Convention on Road Signs and Signals (1968)

Group of Experts on Road Signs and Signals

Submitted by Lithuania and Luxembourg

This document contains the text of the 1968 Convention on Road Signs and Signals with proposed amendments identified as additions (in bold) and deletions (in strikethrough). The document is provided for information only as it is in English only and still subject to editorial reviews. Contracting Parties are invited to provide substantive and editorial comments in writing to the secretariat until 1 July 2023.

FALLING ROCKS

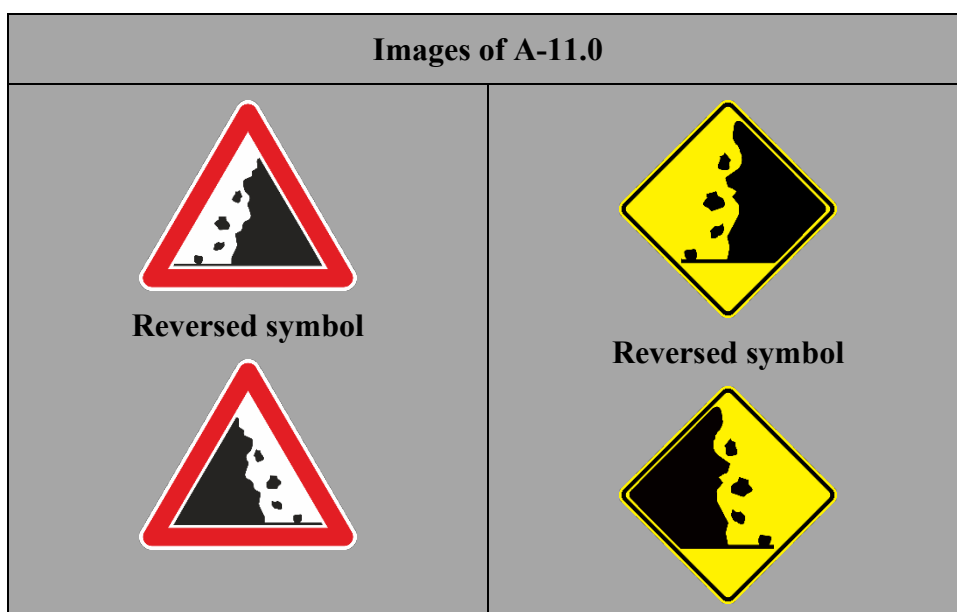
(a) ~~Warning of a section of road on which there is danger from falling rocks and the consequent presence of rocks on the carriageway shall be given by symbol A, 11a used with the sign of model Aa or by symbol A, 11b with the sign of model Ab.~~

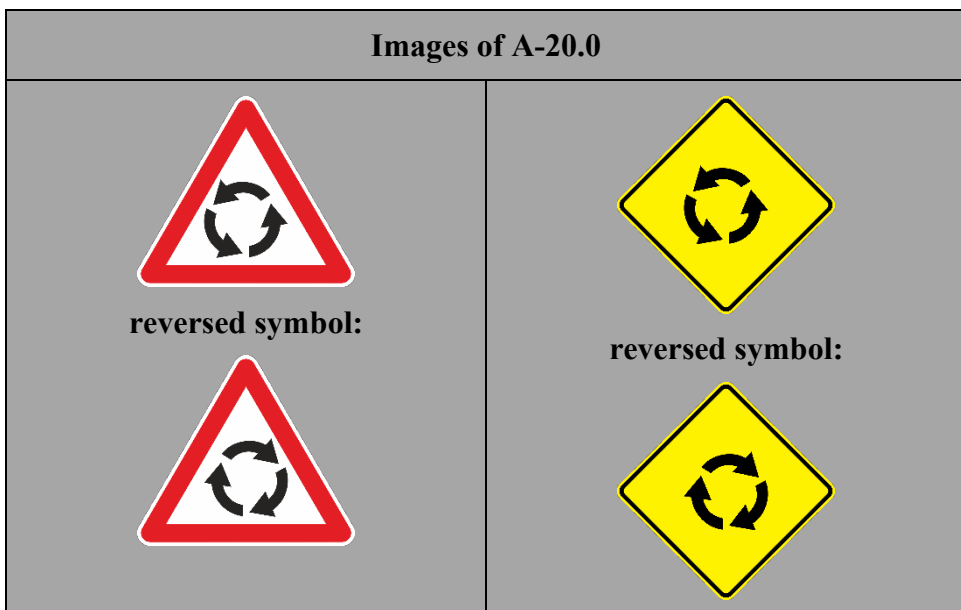
~~(a) If the "GIVE WAY" sign B, 1 is placed at the intersection, the symbol A, 20 shall be used at the approach.~~

~~(b) If the "STOP" sign B, 2 is placed at the intersection, the symbol used at the approach shall be A, 21a or A, 21b whichever corresponds to the model of sign B, 2 set up. (c) However, instead of sign Aa with these symbols, sign B, 1 or sign B, 2 may be used in conformity with Article 10, paragraph 6, of this Convention.~~

TRAFFIC CONGESTION

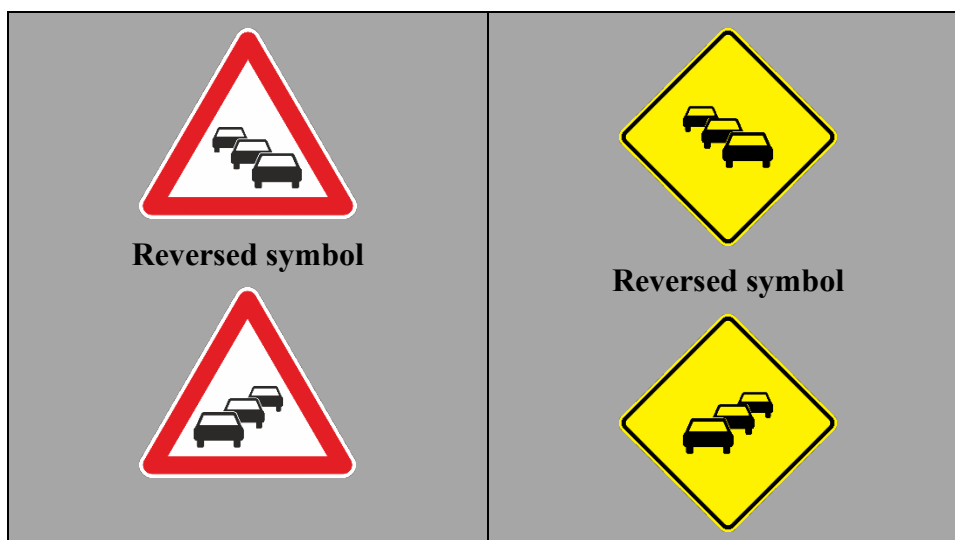
(a) ~~Warning that there may be traffic congestion on the section of road ahead shall be given by symbol A, 24.~~

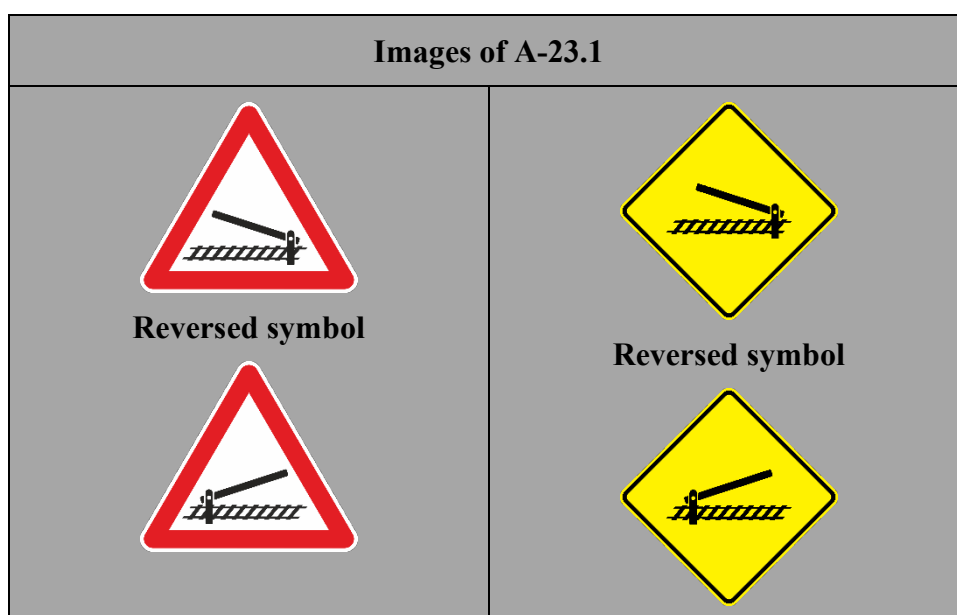
~~Warning of level crossings with gates or staggered half-gates on either side of the railway line, shall be given by symbol A, 25.~~

A-23.1 gives warning of a level crossing with gates or staggered half-gates on either side of the railway. The symbol on this sign may be reversed. The barrier shown on the sign may be of the colours applied by a State concerned in accordance with Article 35, paragraph 1 of this Convention.

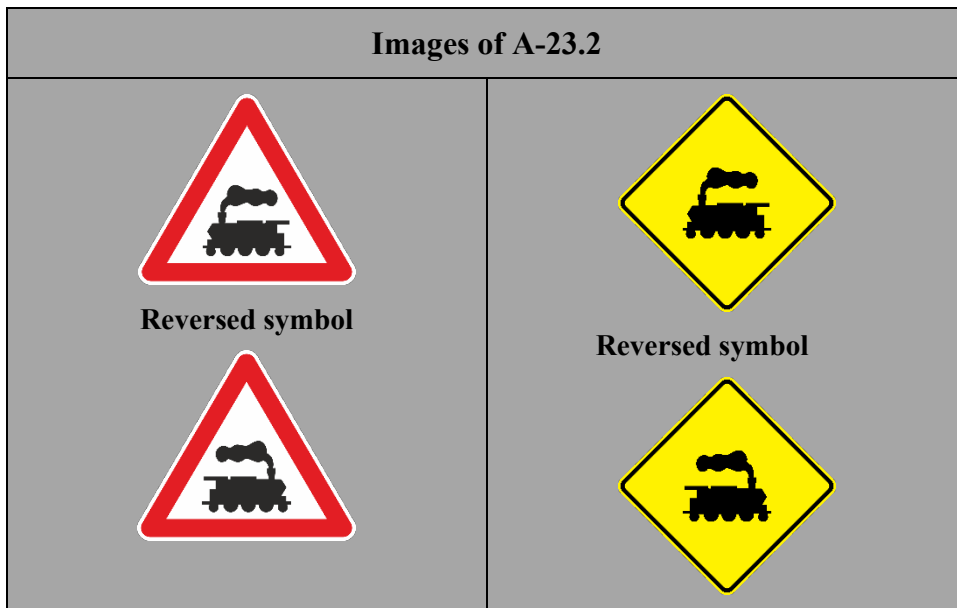
~~Warning of other level crossings shall be given by symbol A, 26 a or A, 26 b, or by symbol A, 27 as appropriate.~~

A-23.2 gives warning of a level crossing without gates or staggered half-gates on either side of the railway. It may be replaced by sign A-23.3 or A-24.0. The symbol on this sign may be reversed for traffic keeping to the left.

GIVE WAY

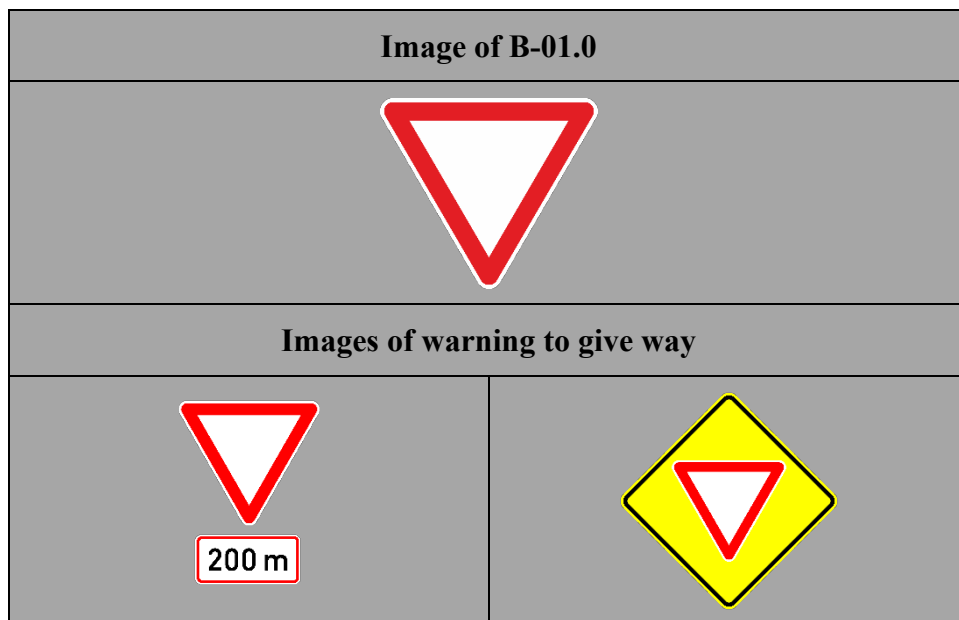
~~(a) The "GIVE WAY" sign shall be sign B, 1. It shall consist of an equilateral triangle having one side horizontal and the opposite vertex below it. The ground shall be white or yellow and the border red. The sign shall bear no symbol.~~

B-01.0 notifies drivers that, at the intersection where the sign is placed, they must give way to vehicles on the road they are approaching. The sign shall consist of an equilateral triangle having one side horizontal and the opposite vertex below it. The ground shall be white or yellow with a red border. The sign shall not bear a symbol.

STOP

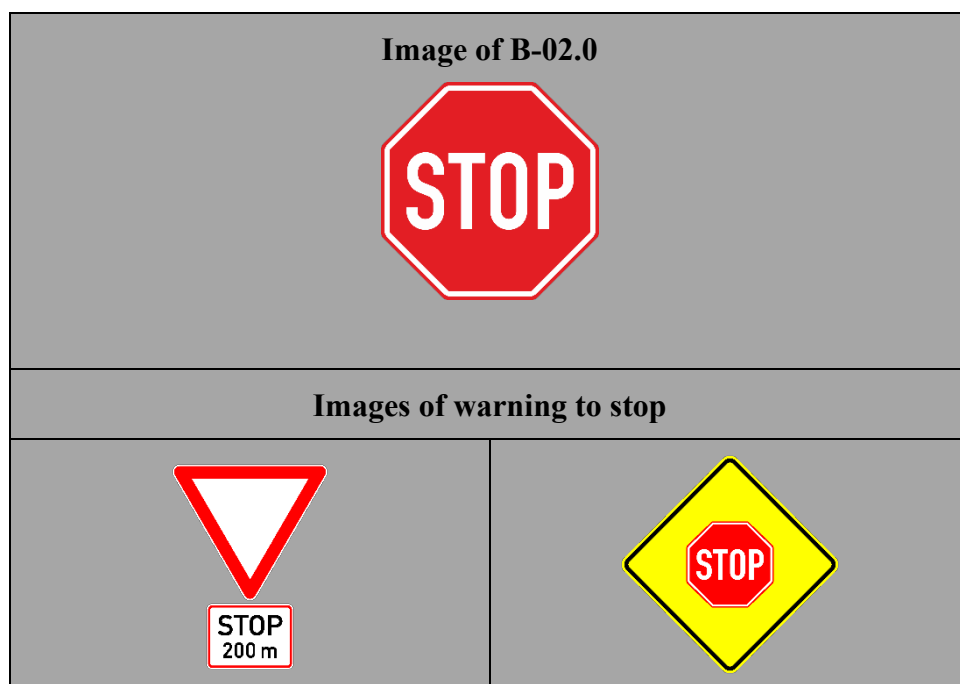
~~(b) The height of the normal sized sign B, 2a~~**B-02.0** and the diameter of the normal sized sign B, 2b shall be approximately 0.90 m; the same dimensions of the small signs and shall be not less than 0.60 m for a small sized sign.

B-02.0 notifies drivers that, at the intersection where the sign is placed, they must stop before entering the intersection and give way to vehicles on the road they are approaching. The sign is an octagon with a red ground surrounded by a white rim and bears the "STOP" inscription in white in English or in the language of the State concerned. The height of the inscription shall not be less than one-third of the height of the panel.

PEDESTRIAN CROSSING

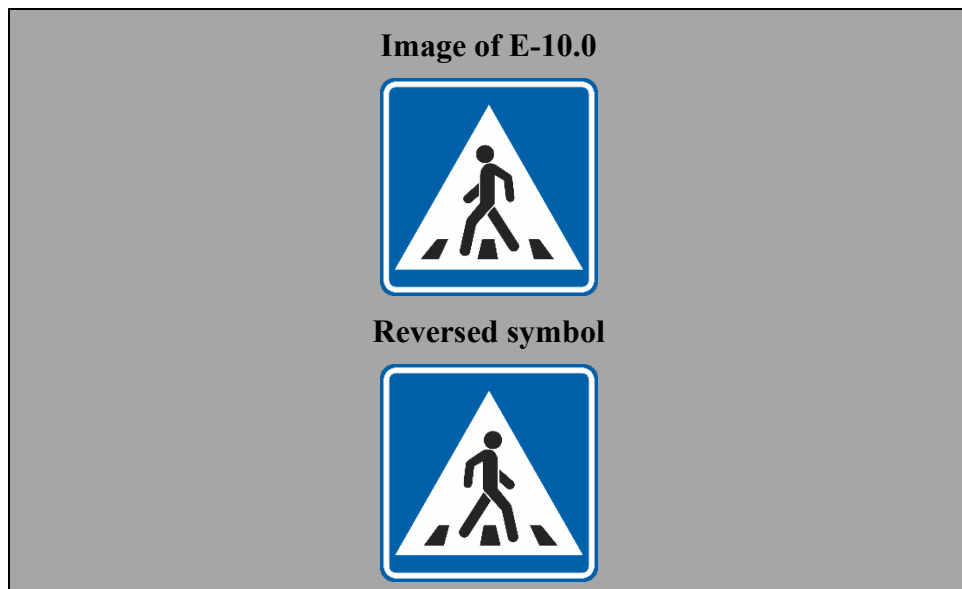
(a) Sign E, 12 E-10.0, "PEDESTRIAN CROSSING", notifies road users of is used to show pedestrians and drivers the position of a pedestrian crossing. The ground of the panel this sign shall be blue or black with the triangle a white or yellow triangle. and the symbol shall be black or dark blue. the This symbol shall symbol displayed shall be a pedestrian on a crossing marked by broad stripes. symbol as A, 12 a (A 12.1). The symbol on this sign may be reversed.

PICNIC SITE OR REST AREA

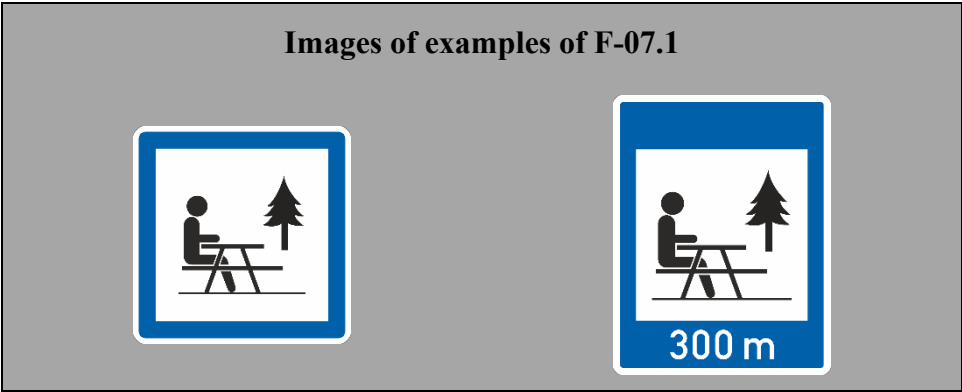
F-07.1 "~~PICNIC SITE~~" notifies of a location of a picnic site or a rest area.

CAMPING SITE

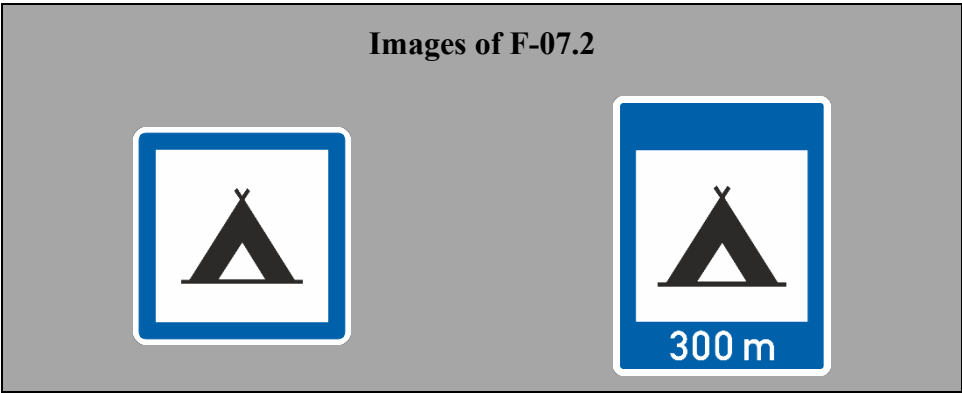
~~F-07.2 "CAMPING SITE"~~ notifies of a location of a camping site.

CARAVAN SITE

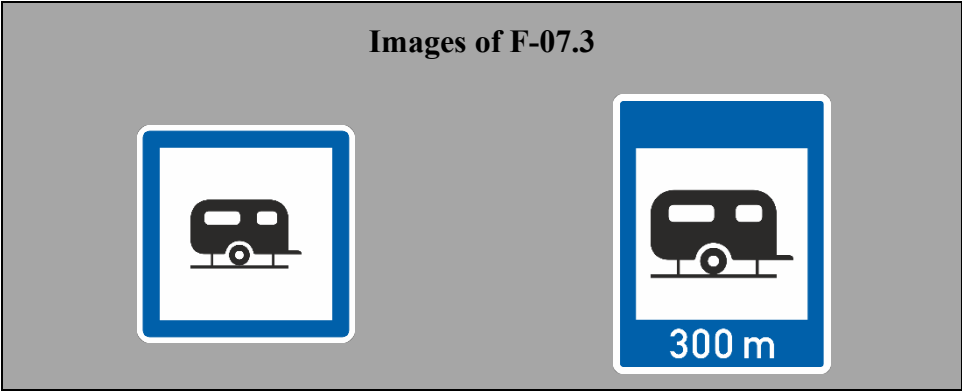
~~F-07.3 "CARAVAN SITE"~~ notifies of a location of a caravan site.

EMERGENCY EXIT

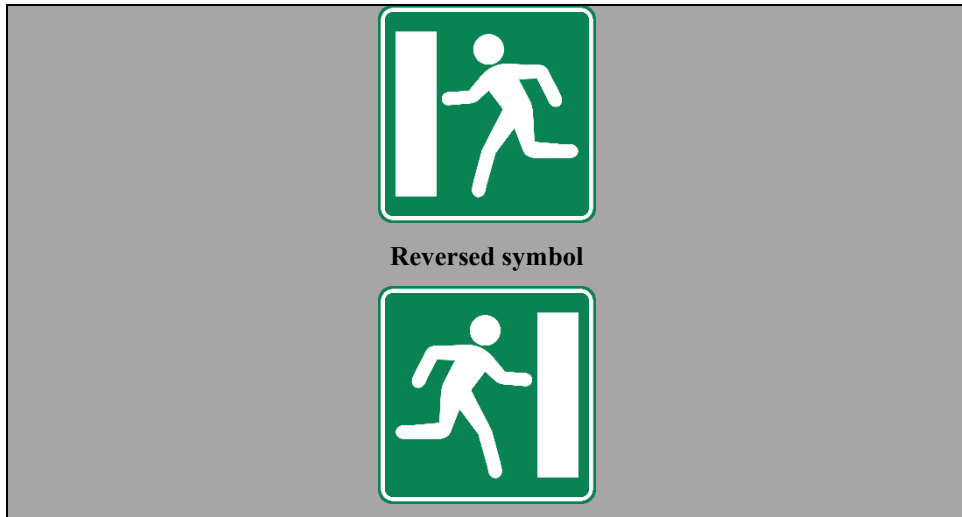
(a) The signs G, 23 a and G, 23 b indicate the G-23.0 notifies of a location of an emergency exits. The symbol on this sign may be reversed.
